# STOCKADE ST400 FENCE POST STAPLER A12605

## ILLUSTRATED PARTS LIST

# STOCKADE ST400 Fence Post Stapler A12605

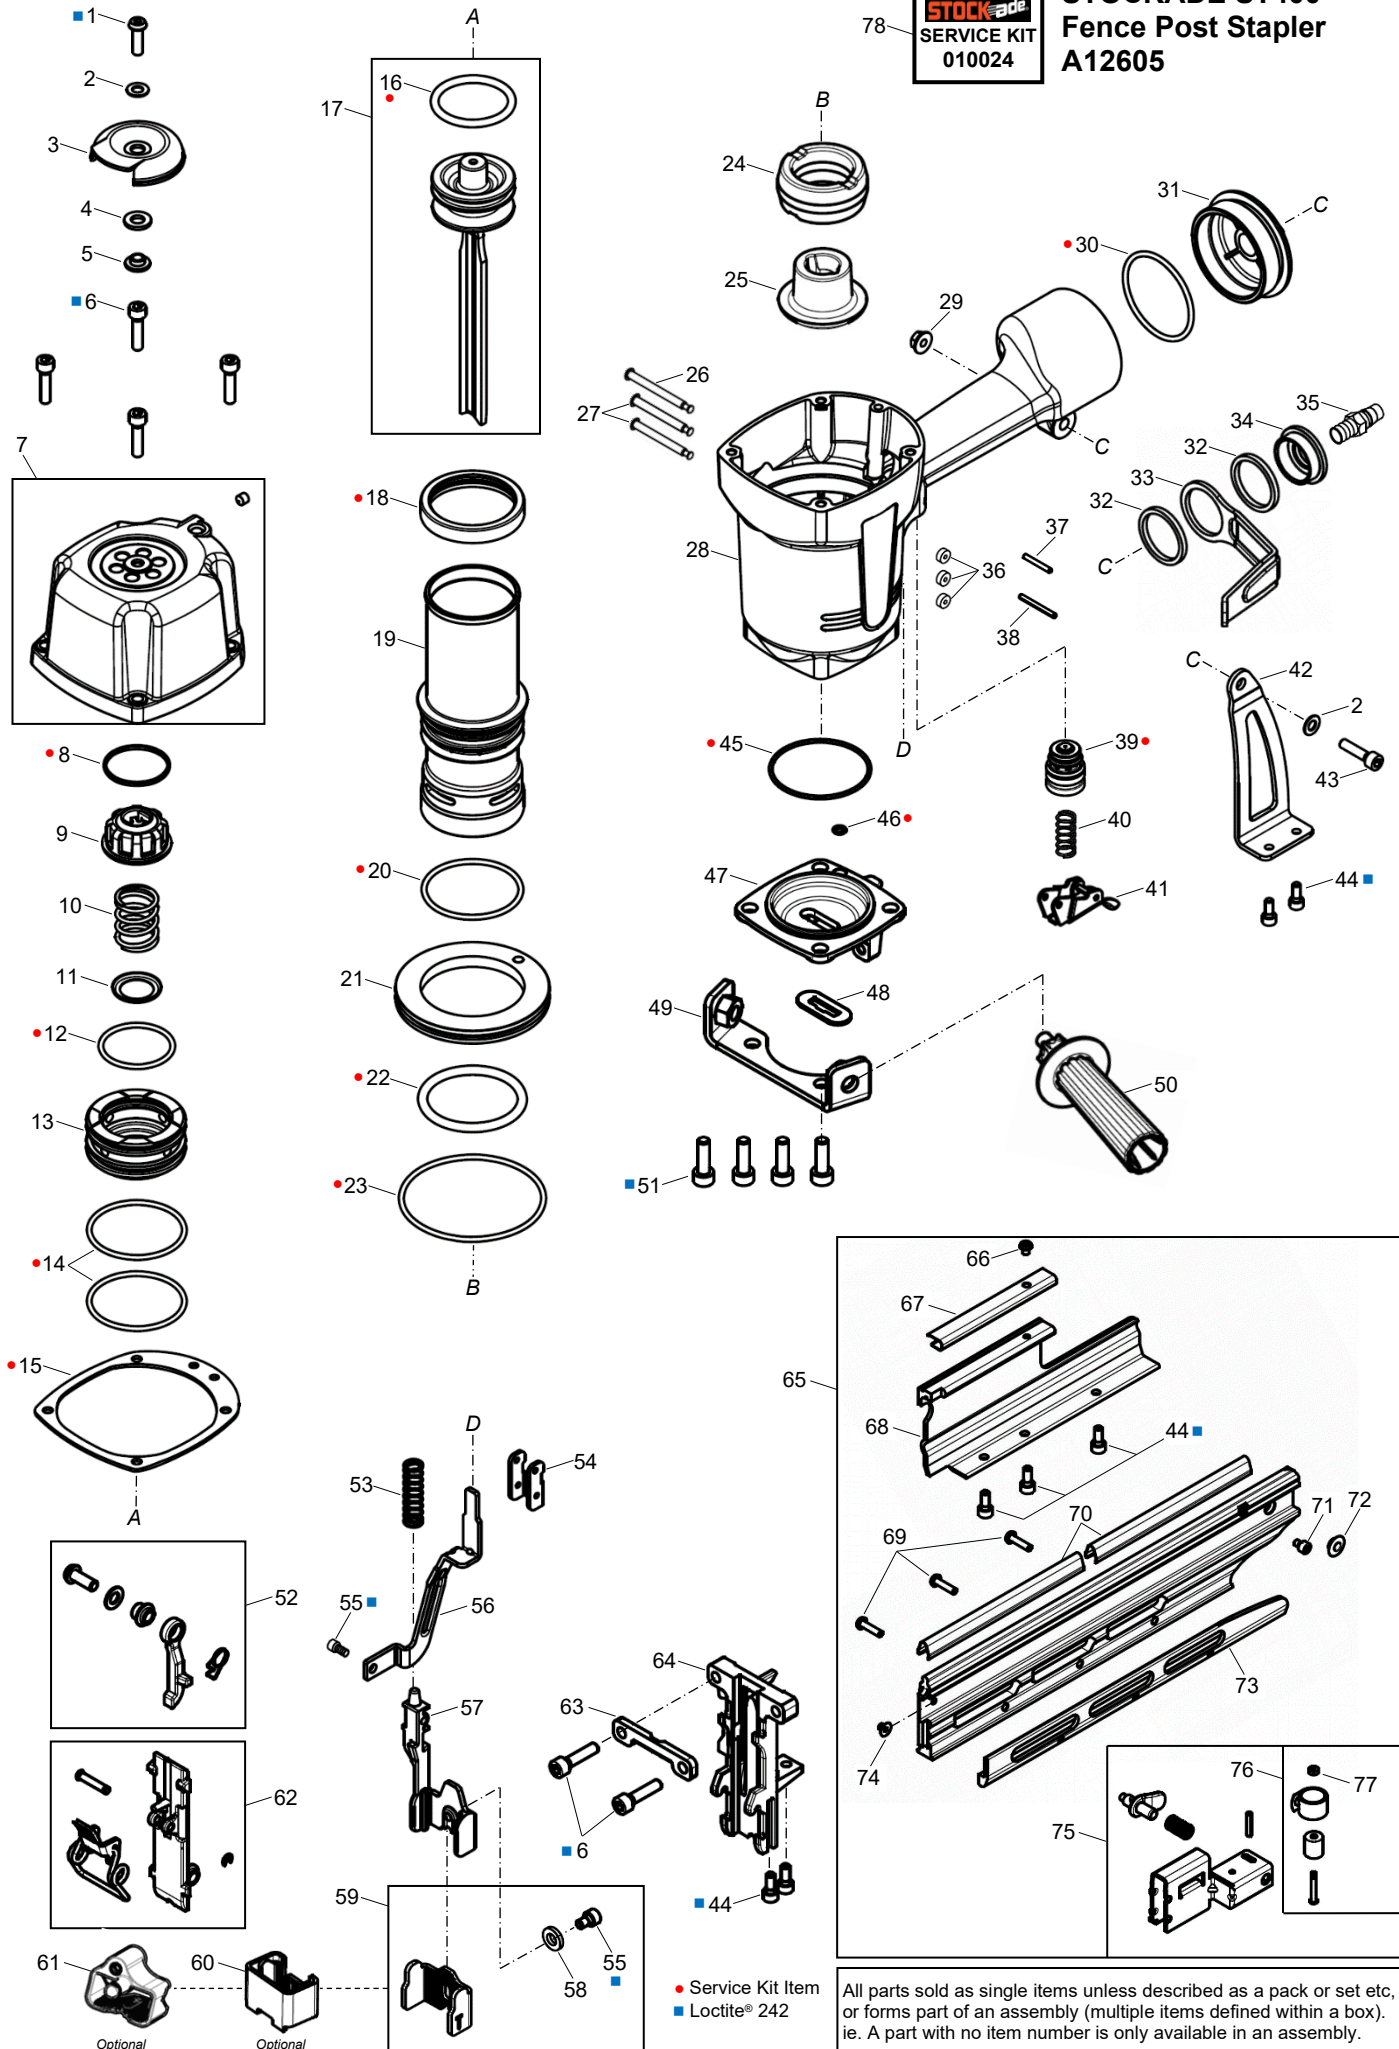
| Item | Part No.  | Item Description    | Change        | Action/Change Description            |
|------|-----------|---------------------|---------------|--------------------------------------|
| 13   | 25400903  | Main Valve          | Manufacturing | Replaced by 23300902 (Superceded R4) |

| Item | Part No.     | Item Description         | Change        | Action/Change Description         |
|------|--------------|--------------------------|---------------|-----------------------------------|
| 35   | 16108008     | Adaptor, Air Inlet (ANZ) | Manufacturing | Replaced by 12106417              |
| 44   | HS05080LW-12 | Screw SHC SEMS           | Correction    | PN typo corrected to HS05080LW-20 |

| Item | Part No. | Item Description    | Change        | Action/Change Description                |
|------|----------|---------------------|---------------|------------------------------------------|
| 13   | 23300902 | Main Valve          | Manufacturing | Replaced by 23300903                     |
| *87  | 41803001 | Handle Grip Bracket |               | Replaced by 41803001A                    |
| *88  | LN1000N  | Lock Nut            |               | Discontinued - Nut now welded to bracket |

| Item | Part No.     | Item Description     | Change        | Action/Change Description                                                       |
|------|--------------|----------------------|---------------|---------------------------------------------------------------------------------|
| 10   | 23300701     | Spring               | Manufacturing | Replaced by 23300702                                                            |
| 24   | 23304801     | Outer Bumper         |               | Replaced by 23304802                                                            |
| 39   | 23303804A    | Trigger Valve        |               | Replaced by 41607301A                                                           |
| 64   | 41800701     | Nose                 |               | Replaced by 41800702                                                            |
| *45  | 41800801-B01 | Magazine             | Design        | Additional (top) mounting hole added<br>(Rolling incorporation - No PN changes) |
| 44   | HS05080LW-20 | Screw SHC SEMS       |               | x 1 added to item QTY for above change                                          |

| Item | Part No.     | Item Description                          | Change        | Action/Change Description                                                                                                      |
|------|--------------|-------------------------------------------|---------------|--------------------------------------------------------------------------------------------------------------------------------|
| 2    | FW060130B-10 | Flat Washer                               | Availability  | x 1 subtracted from item QTY for change to item 52                                                                             |
| 38   | RP3030S      | Roll Pin                                  | Correction    | x 1 added to item QTY                                                                                                          |
| 53   | 38303201     | Spring                                    | Manufacturing | Replaced by 38303202                                                                                                           |
| 59   | 41801901     | Probe Adaptor (1V Notch)                  | Design        | Replaced by 47700102 (3V Notches) (ex 400i)                                                                                    |
|      | 47700102     | Probe Adaptor (3V Notches)                |               | Replaced by Kit 47702401A (3V Notches).<br>Included screw (55) & washer (58) (ex 400i)                                         |
| 60   | 41802201A    | Probe Adaptor, Block                      |               | Replaced by 47701801A (ex 400i)                                                                                                |
